eTIR conceptual, functional and technical documentation

Approved amendments to the eTIR conceptual, functional and technical documentation - v.4.2a

Note by the secretariat

Figure 3
Guarantee status chart diagram

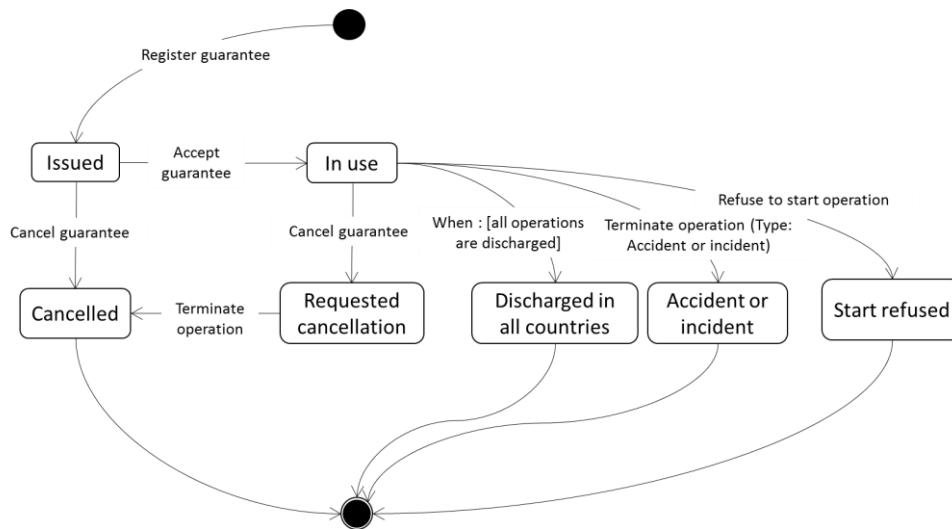
6. Chapter “3.1.2 Guarantee state chart diagram” of the eTIR concepts document will list the two additional guarantee statuses.

7. Figure 3 in the same document will be amended as follows:

CL22	Guarantee status (eTIR)
001	Issued
002	In use
003	Cancelled
004	Requested cancellation
005	Discharged in all countries
006	Accident or incident
007	Start refused

a. Message sequence for countries of departure

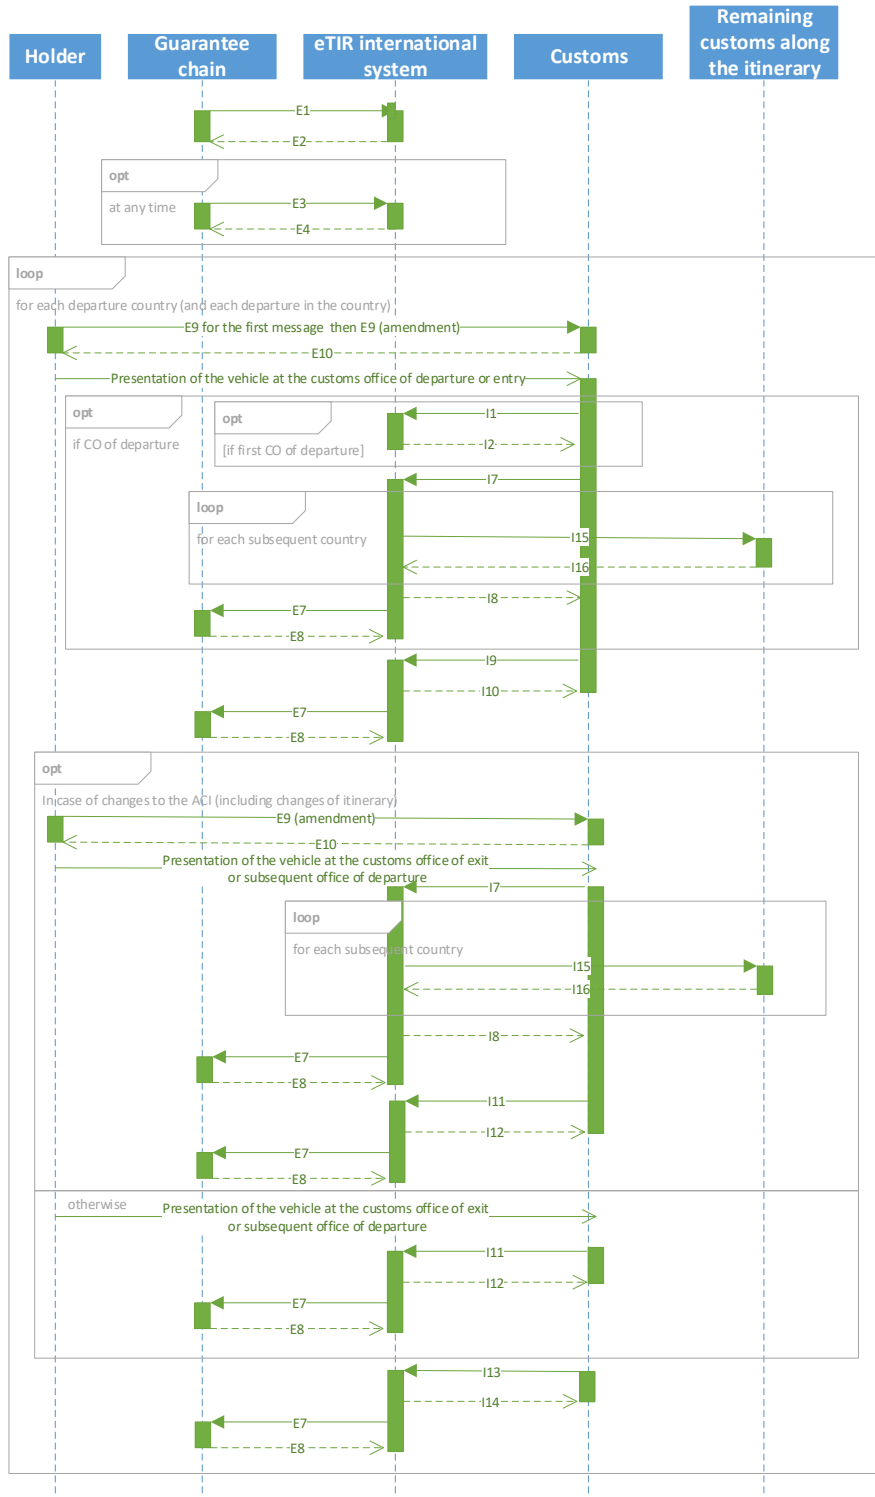
3. The sequence diagrams describing the standard sequences of eTIR messages for countries of departure, transit and destination (as contained in Annex) will be included in the next revision of the eTIR functional specifications as a new Annex.
